Subject: **Memorandum to Resubmittal of Planning Commission Documents
– Greenway Chase Development
610 Peterson Road, Libertyville, IL**

This letter is prepared in response to the Development Committee Report prepared by Village staff dated April 23rd, 2025. The documents included in this resubmittal are provided for review pursuant to a June 9th, 2025 Plan Commission. See below responses to comments provided:

Figure: 9

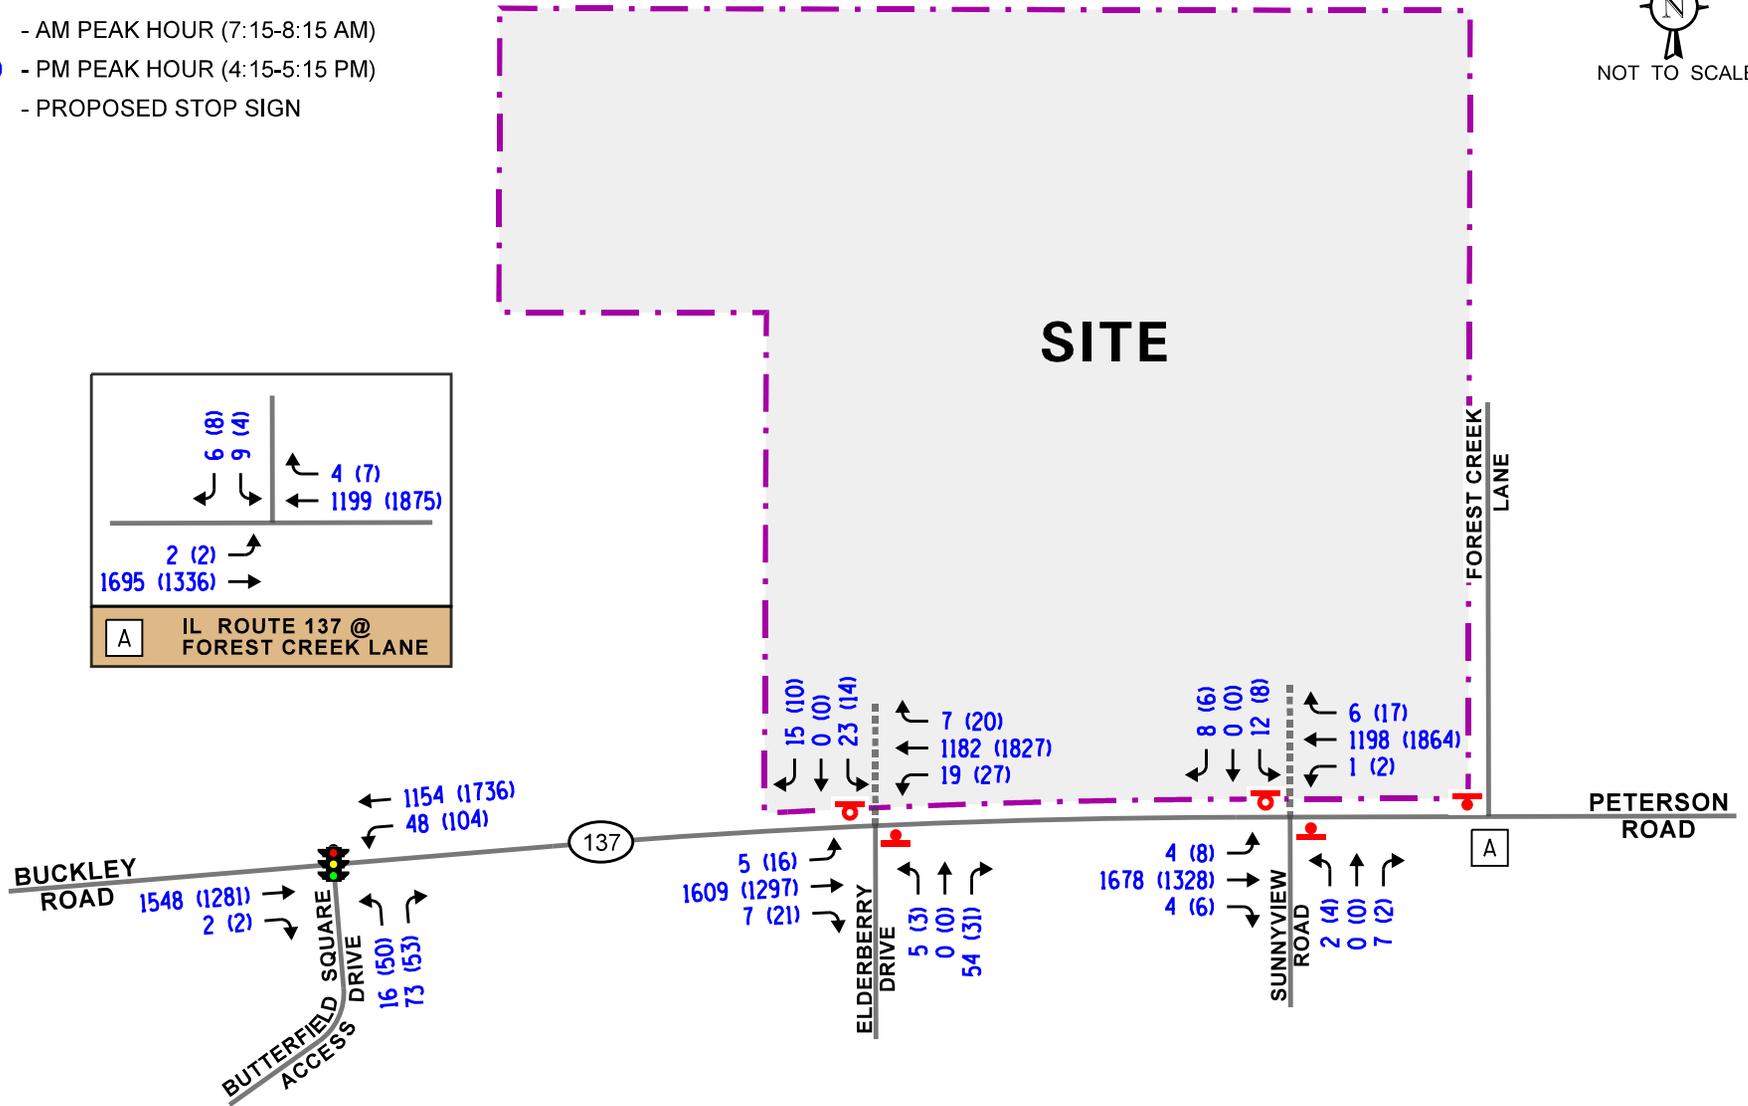
2. While we understand there are no existing stop signs at the Libertyville Manor entrances, they should be shown on the TIS figures to reflect the actual type of traffic control on those approaches, especially the total traffic exhibit on Figure 9, which should reflect proposed traffic control.

Response: Noted. Figures 5 through 9 have been revised to show the proposed stop signs. See revised traffic impact study.

L1.0

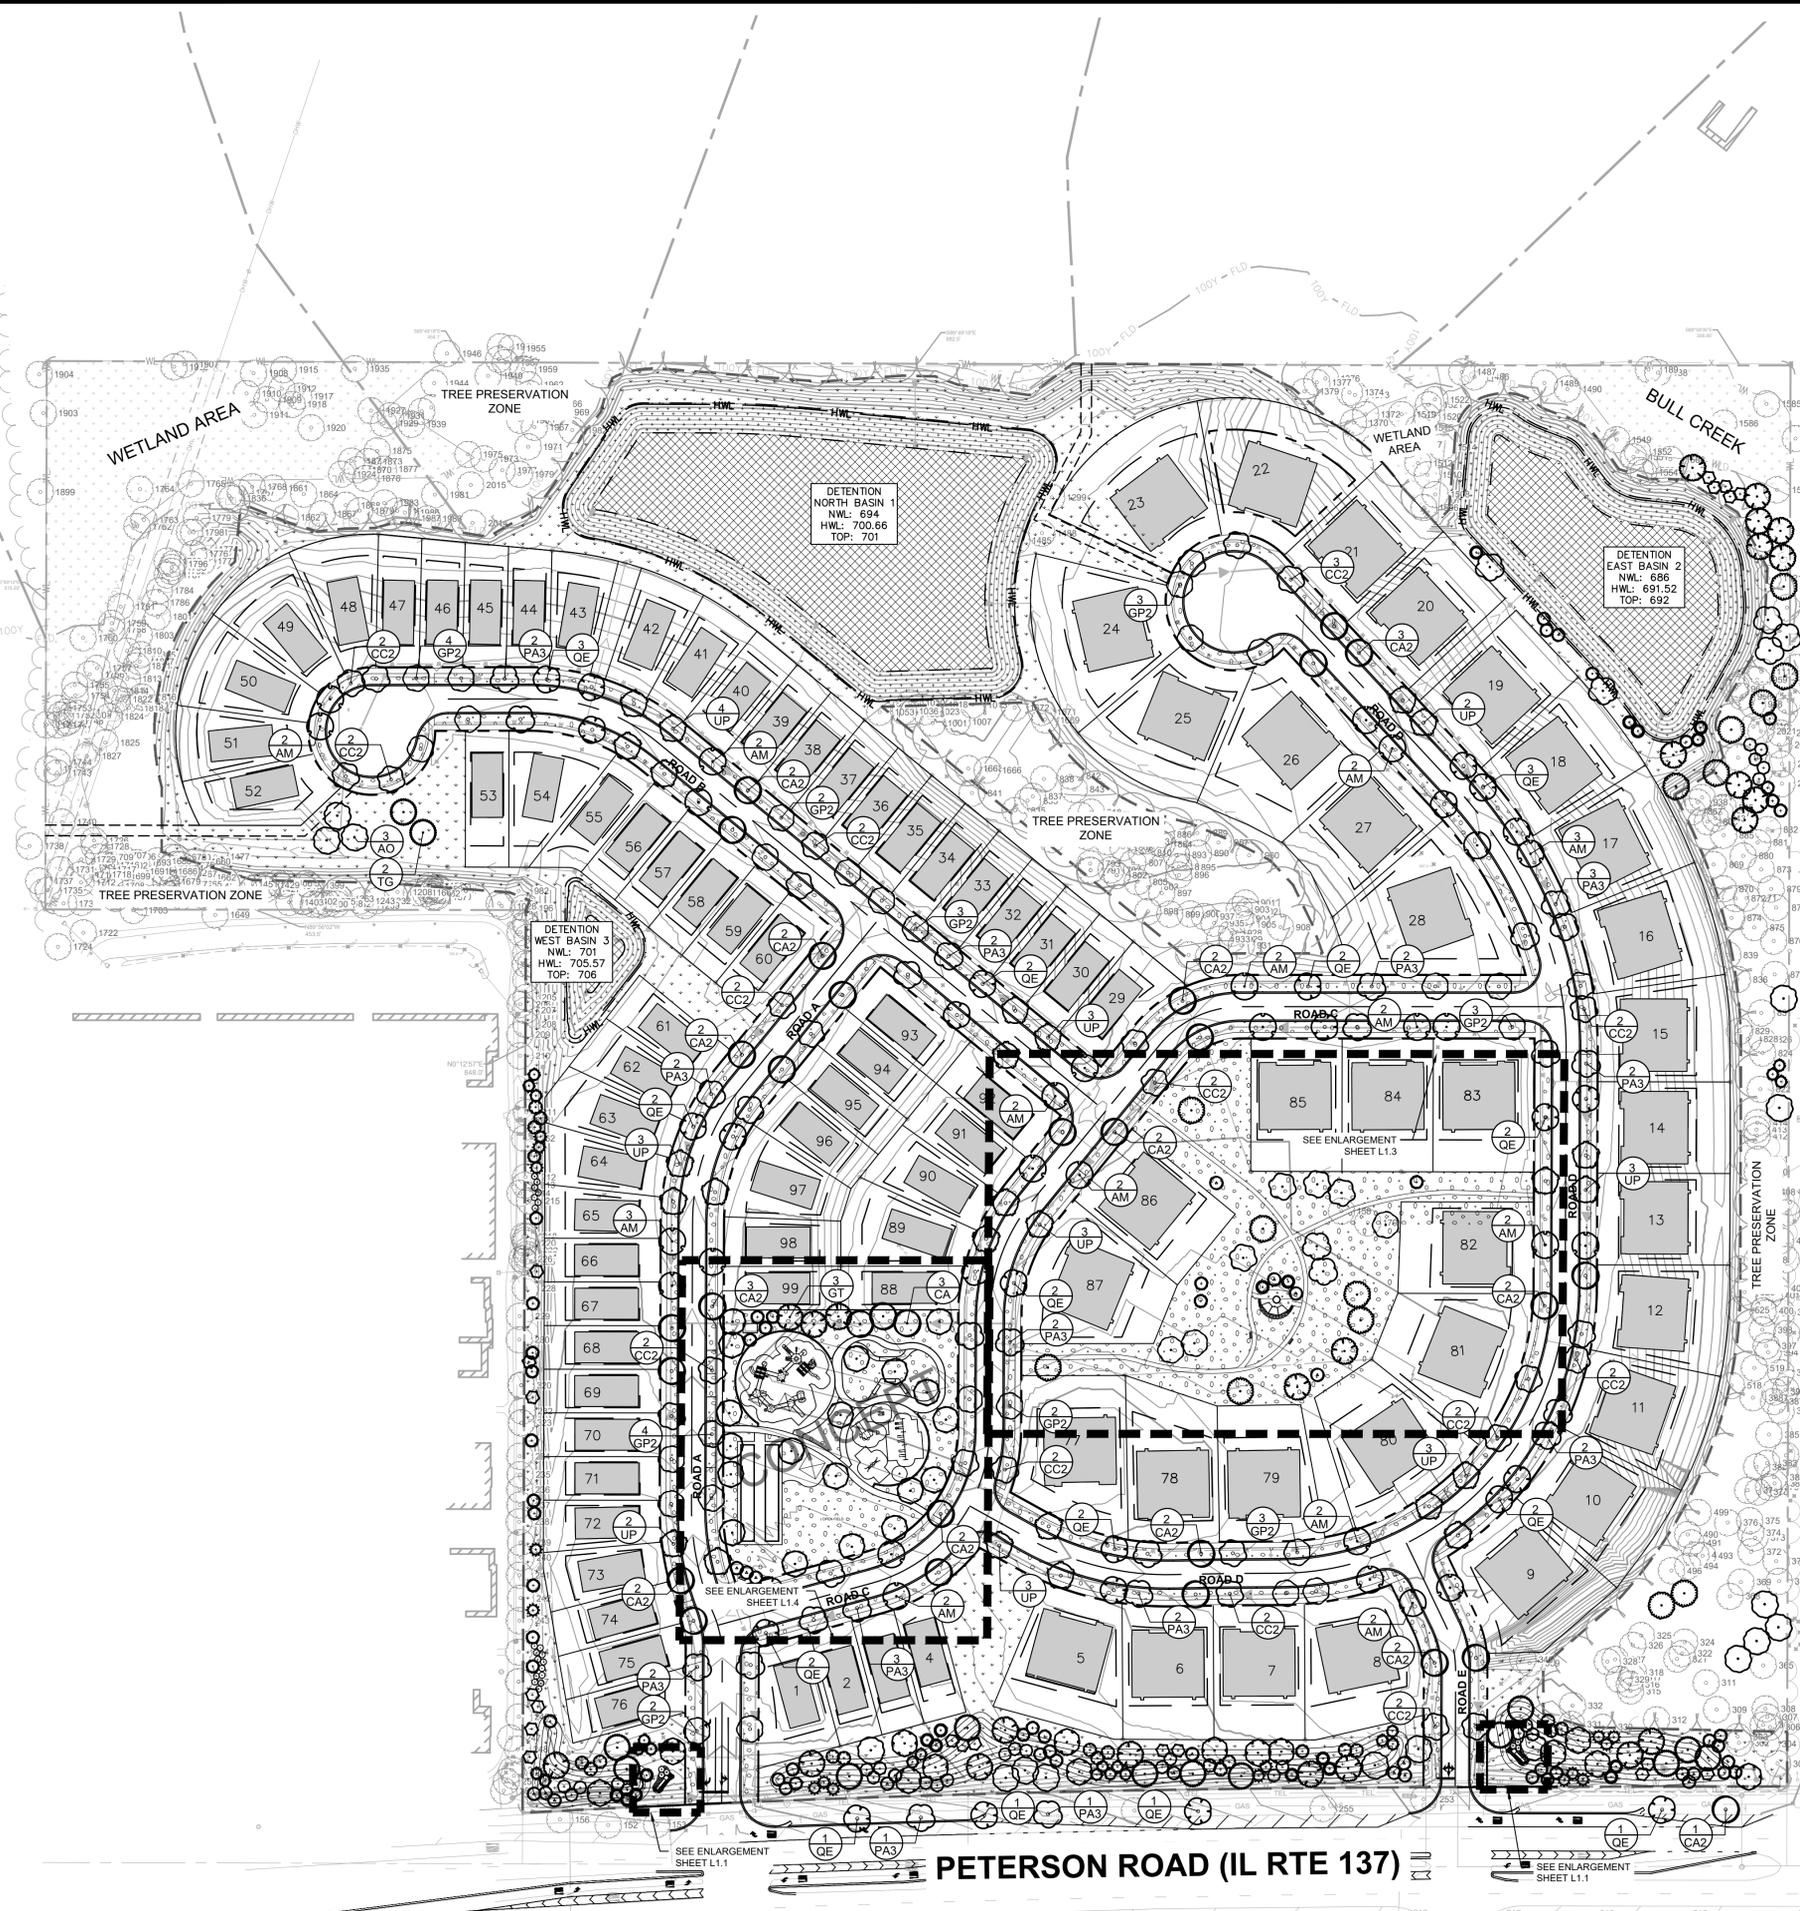
4. Sheet L1.0, Landscape Plan of the preliminary landscape plan, dated March 7, 2025, designed by Kimley Horn, shows a landscape buffer between Victoria Park and the subject development. Staff notes that the final quantities of trees are to be field verified to provide additional screening. While final quantities for the proposed landscape buffer have not yet been determined, they should not be less than what is currently shown. Consideration should be given to additional trees where possible and low ground shrubbery to fill any gaps within the landscape buffer.

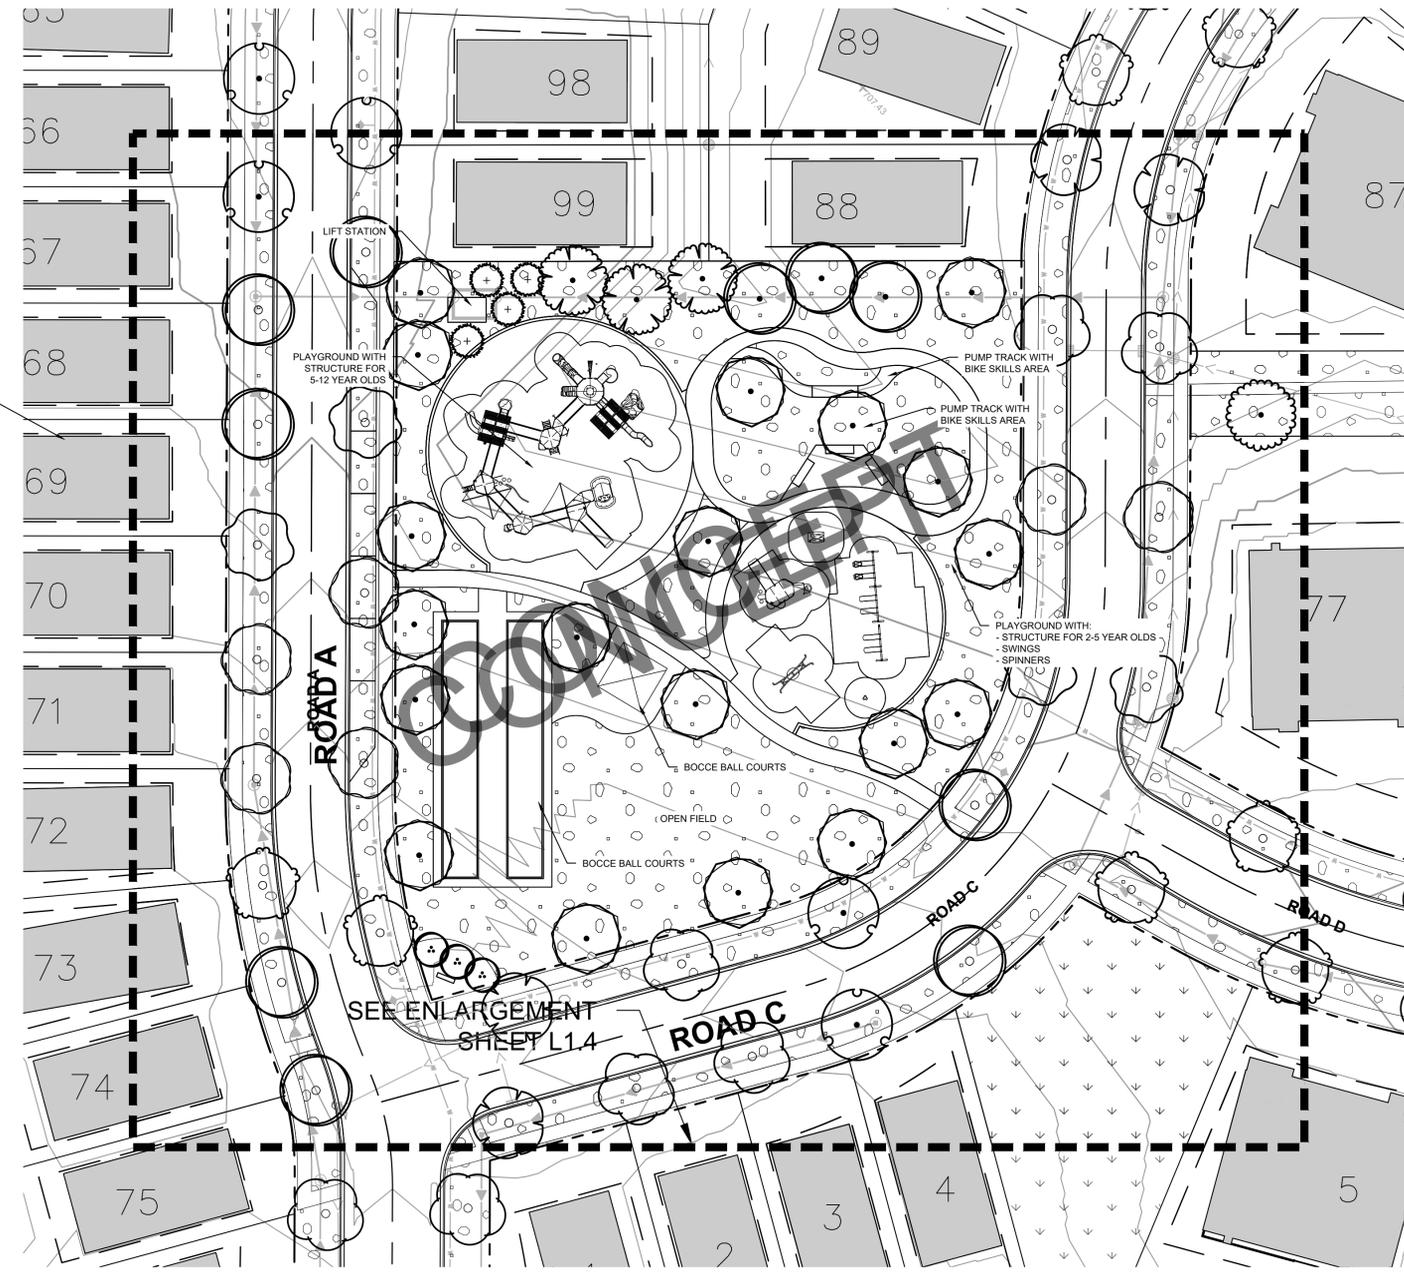
2. All individual lot landscaping including trees, shrubs, ornamental grasses and perennials as depicted on Sheets L1.4 and L1.5 shall be regulated by the HOA Declarations, Covenant, Conditions and Restrictions (DCCR) to maintain a minimum amount of plantings. Any reduction to the minimum landscaping as reflected on the approved landscape plan by an individual homeowner shall be regulated by the HOA. Removal of trees on an individual lot shall be subject to both the HOA's DCCRs and the Village of Libertyville Tree Preservation Ordinance as amended from time to time.
